**HORIZONTAL DIRECTIONAL DRILL ANALYSIS  
GOLDFINCH LANE CROSSING  
PADEP SECTION 105 PERMIT NO.: E11-352  
PA-CA-0016.0000-RD and PA-CA-0016.0000-RD-16  
(SPLP HDD No. S2-0069)**

This reanalysis of the horizontal directional drill (HDD) of the Sunoco Pipeline, LP (SPLP) 16-inch and 20-inch diameter pipeline crossing of streams S-N41 and S-N42 (both unnamed tributaries to Hinckston Run), Wetlands N25, N26, and N27, and Goldfinch Lane in Jackson Township, Cambria County, is in accordance with Stipulated Order issued under Environmental Hearing Board Docket No. 2017-009-L for HDDs listed on Exhibit 2 of the Stipulated Order. This HDD is number 5 on the list of HDDs included on Exhibit 2. This HDD was not initiated before the issuance of the Order.

It is SPLP’s intent to modify the original profile design and to pursue a deeper and longer HDD profile. Figure 1 and 3 in Attachment 3 presents the original HDD plan and profiles. Figure 2 and 4 in Attachment 3 present the revised HDD plan and profiles.

**ORIGINAL AND REVISED HORIZONTAL DIRECTIONAL DRILL PLAN AND PROFILES**

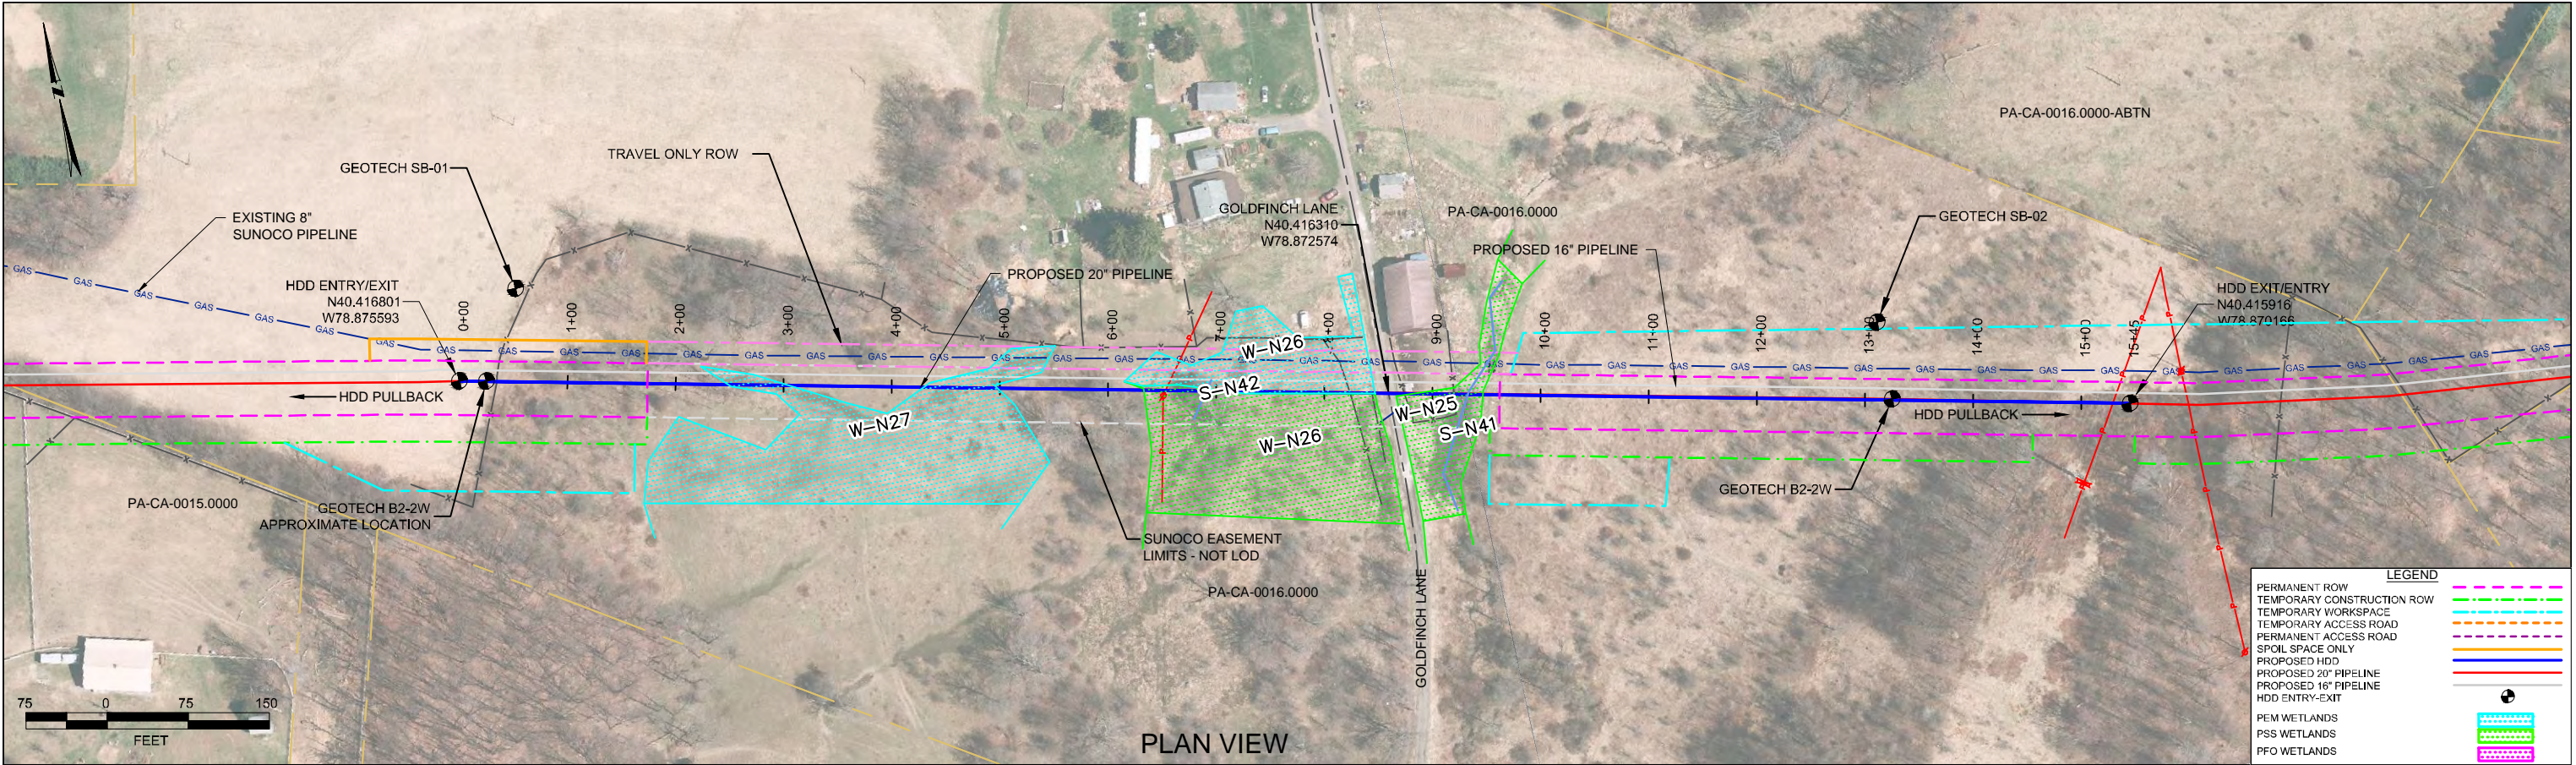
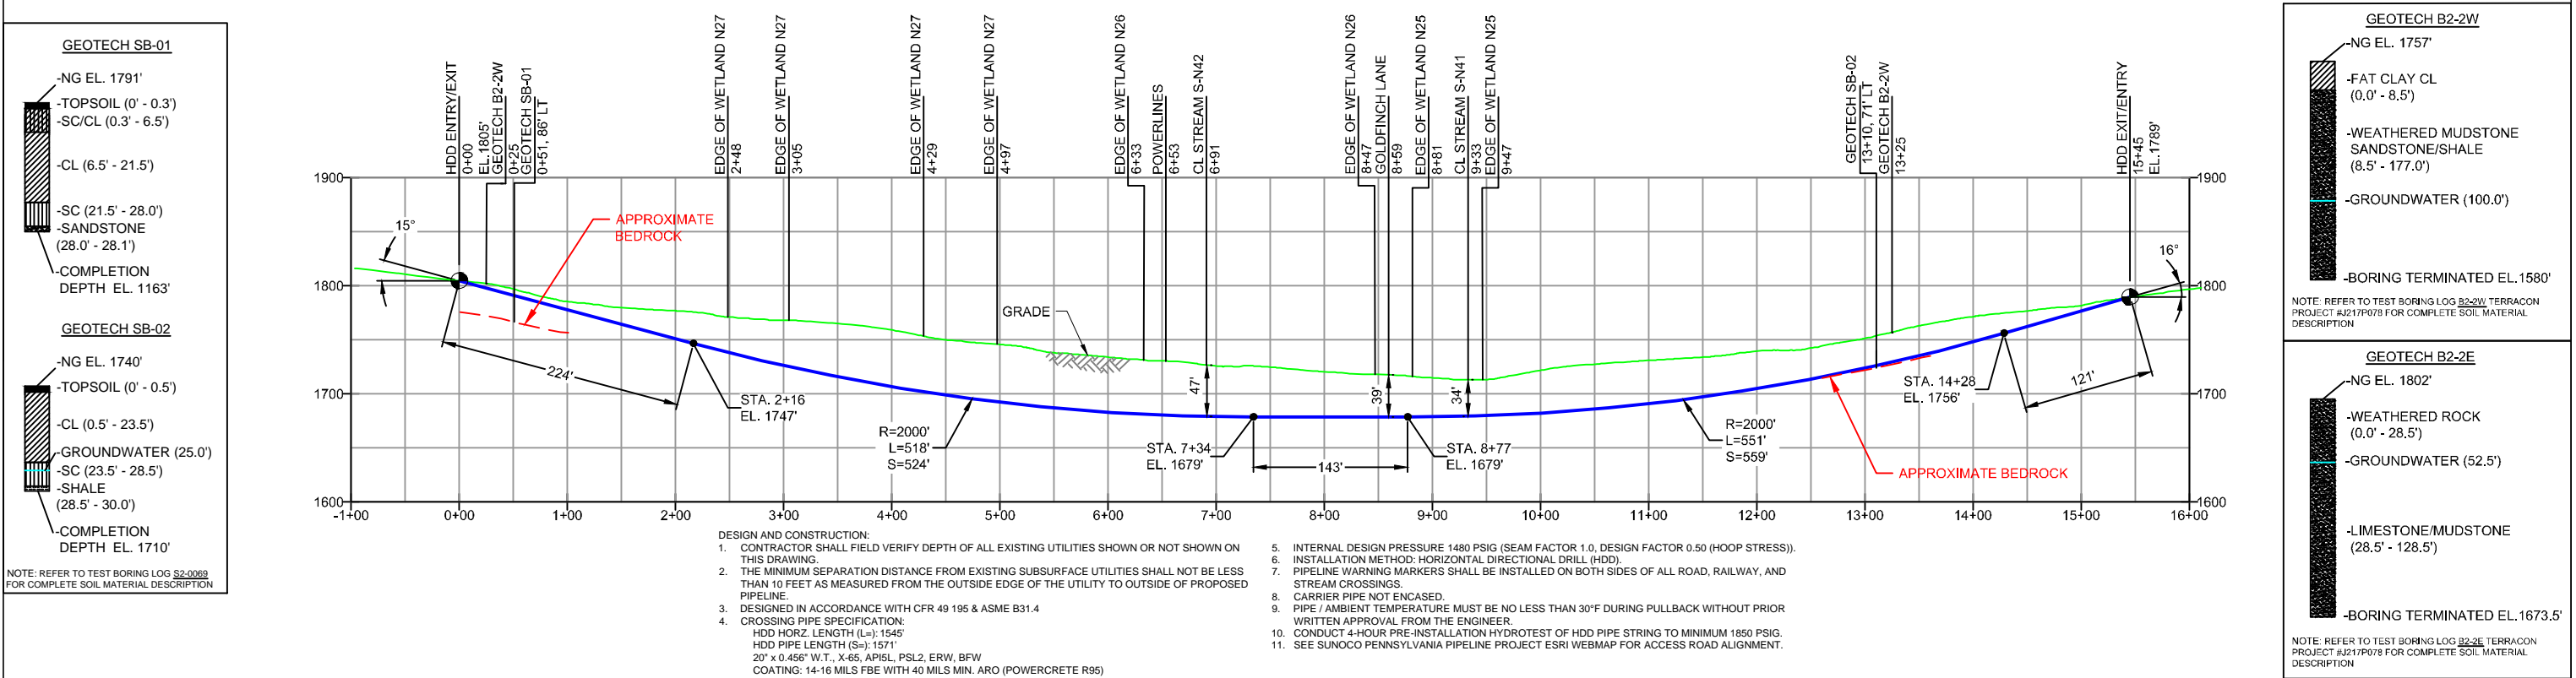
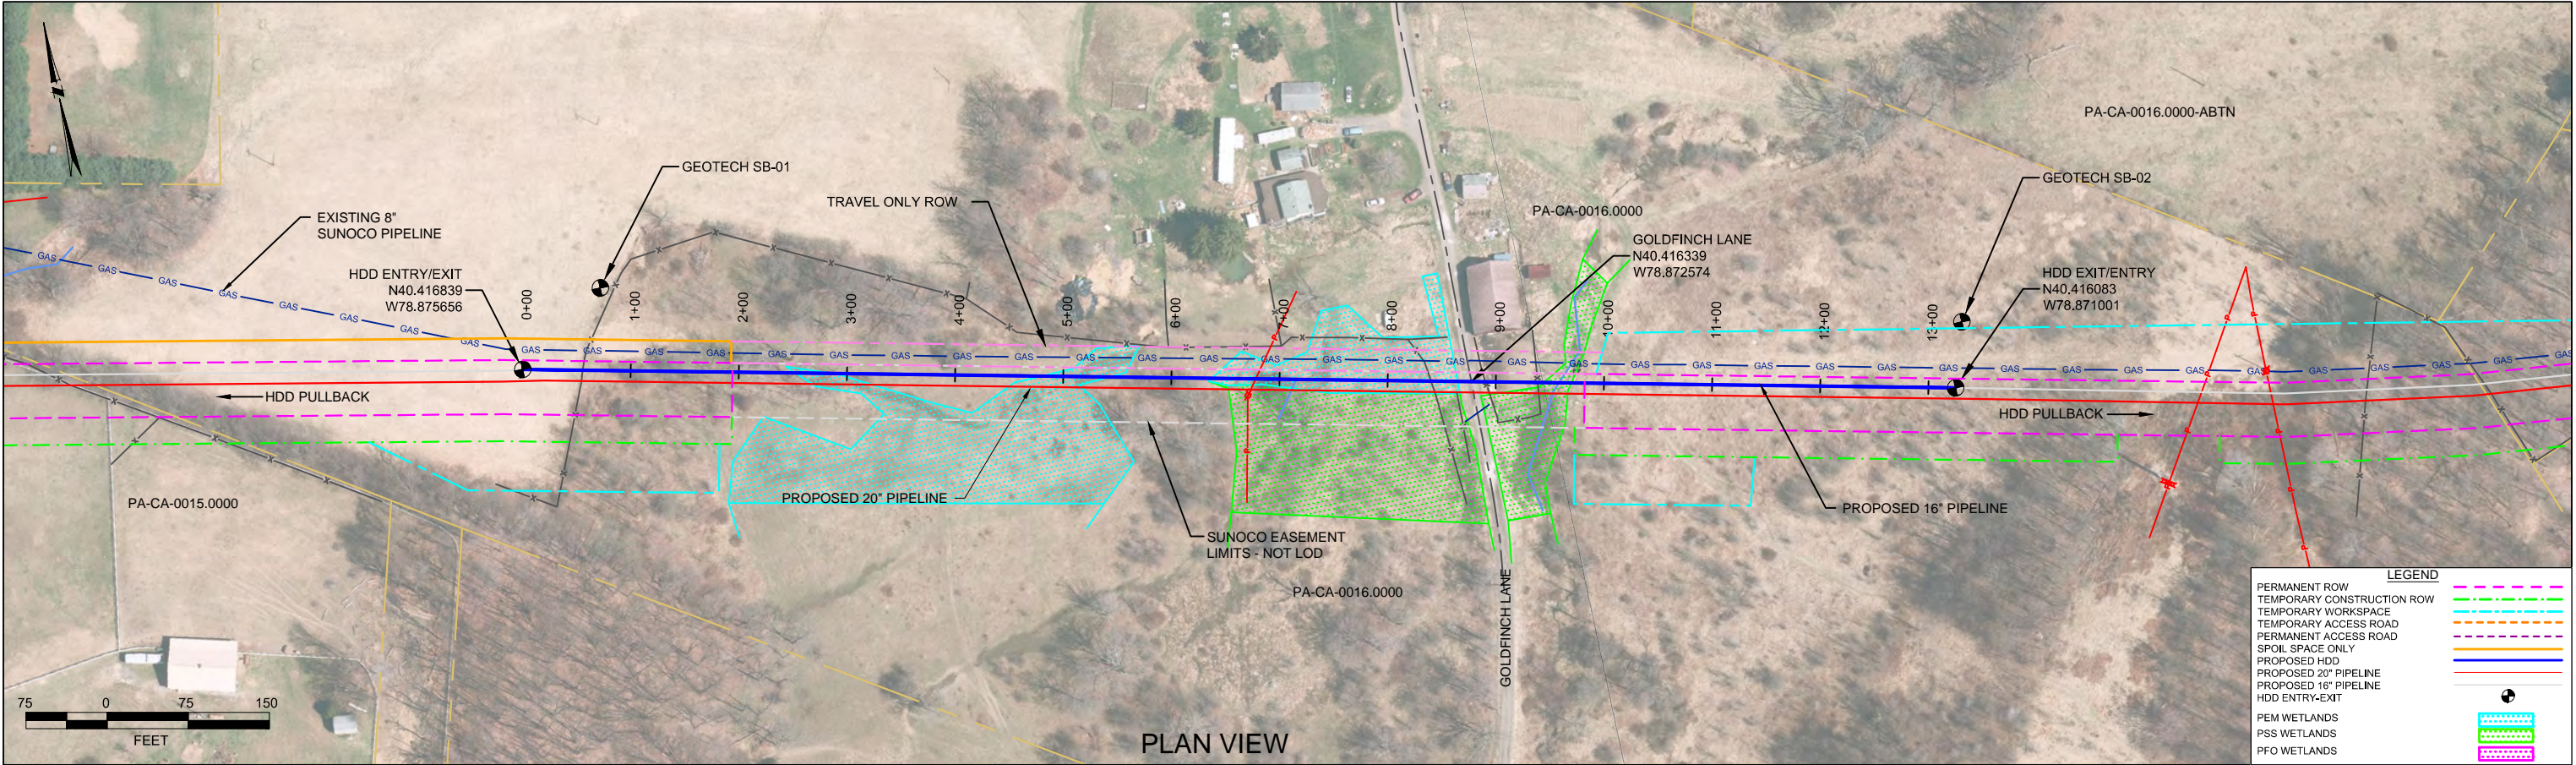
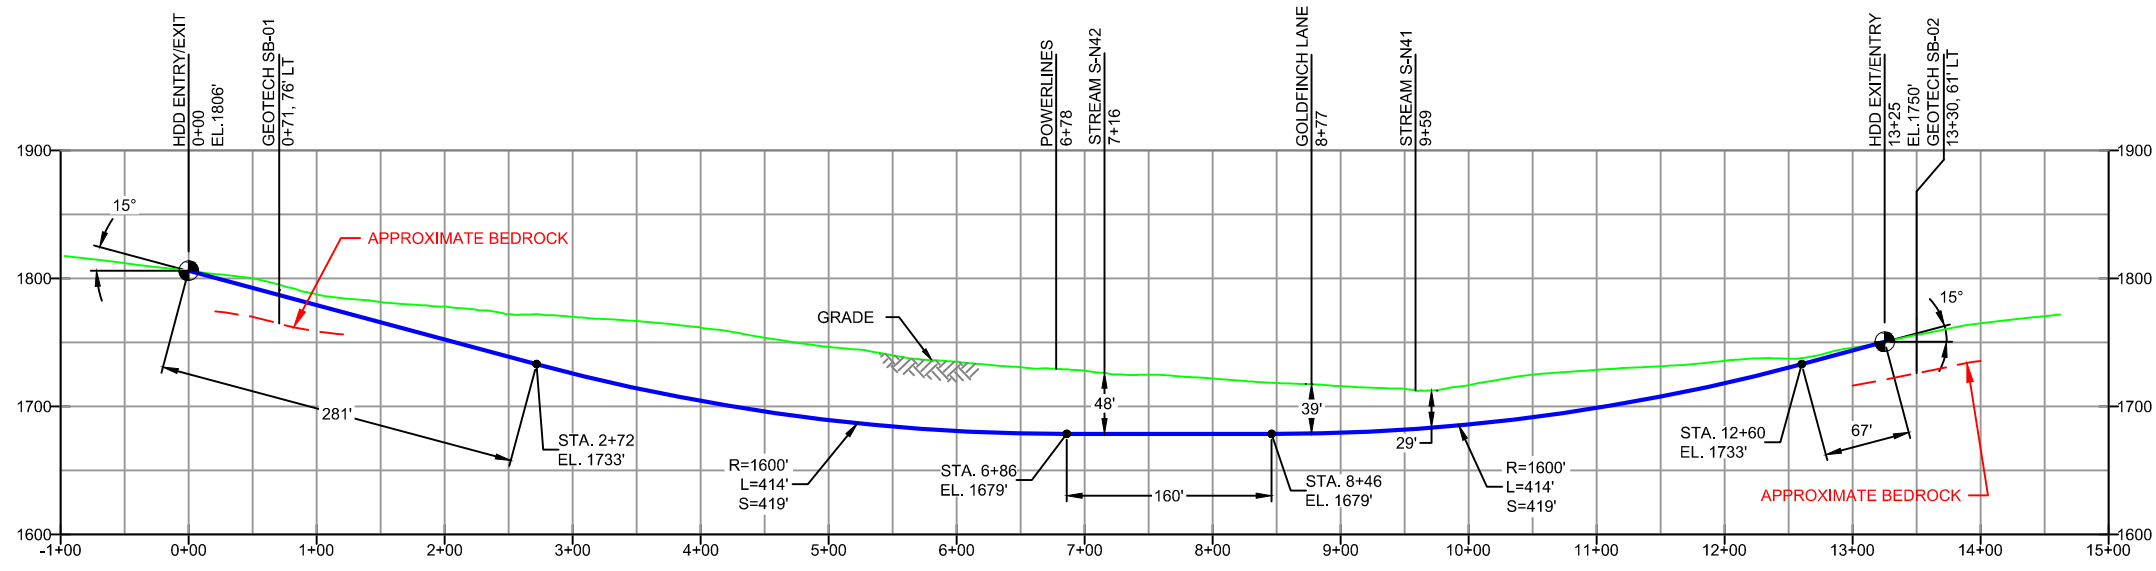
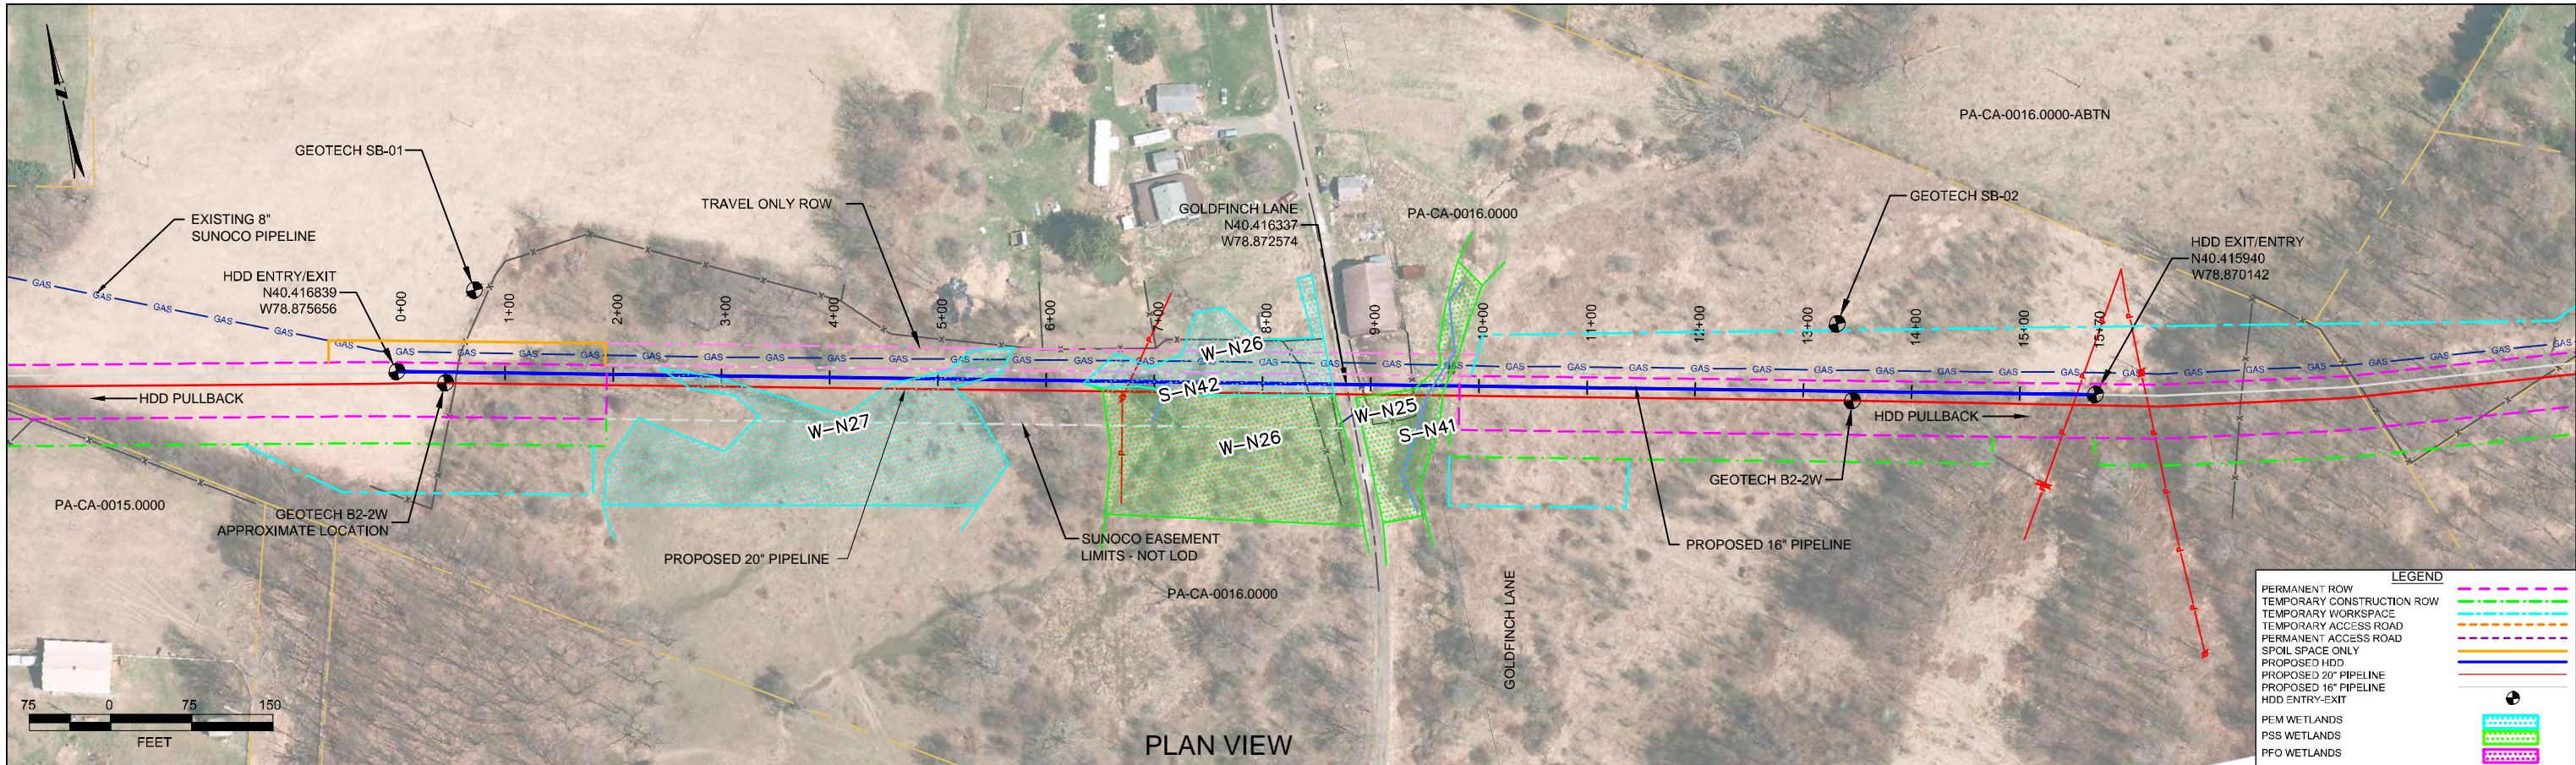
As shown on Figure 2, the redesigned HDD profile for the 20-inch pipeline is 237 ft longer, with a depth of cover below the streams and wetlands increased by 25-30 ft from the permitted design. In addition, the entry/exit angles have been increased allowing for a sharper and quicker descent into more competent rock. As shown on Figure 4 the redesigned HDD profile for the 16-inch pipeline is 99 ft longer, with a depth of cover below the streams and wetlands increased by 19-21 ft and designed for a sharp and quick entry and exit from the horizontal depth.

- Horizontal length: 1,545 foot (ft)
- Entry/Exit angle: 15-16 degrees
- Maximum Depth of cover: 60 ft
- Depth under Goldfinch Lane: 39 ft
- Depth under streams: 34-48 ft
- Depth under wetlands: 34-50 ft
- Pipe design radius: 2,000 ft

- Horizontal length: 1,570 foot (ft)
- Entry/Exit angle: 15 degrees
- Maximum Depth of cover: 67 ft
- Depth under Goldfinch Lane: 59 ft
- Depth under streams: 52-67 ft
- Depth under wetlands: 52-70 ft
- Pipe design radius: 1,600 ft
